AMENDMENT NO. 008

**SUBJECT: Solicitation No. DCSC-21-RFP-087
Migration from Gallery Place Modernization**

Question and Answers Round – 6

SOLICITATION QUESTIONS & ANSWERS: ROUND 06

Figure 6. POR USF Compared to the 2019 Master Plan

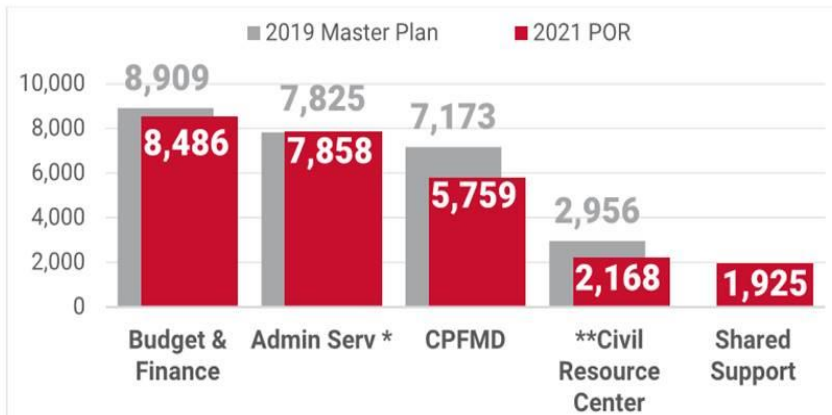
Q.53 Program of Requirements- Attachment J.25 - As a similar question to #47 - the Masterplan of 2019 from the POR document indicates slightly larger space requirements than the current 2021 POR. Please confirm that the POR 2021 is to be followed. (see graphic below)

A.53 The D-B shall verify the 2021 POR data, as it is the most recent and is based on recent interviews with the End Users. The 2019 Master Plan was based on limited data available in 2018, therefore the 2021 POR data that was collected in 2021 supersedes it.
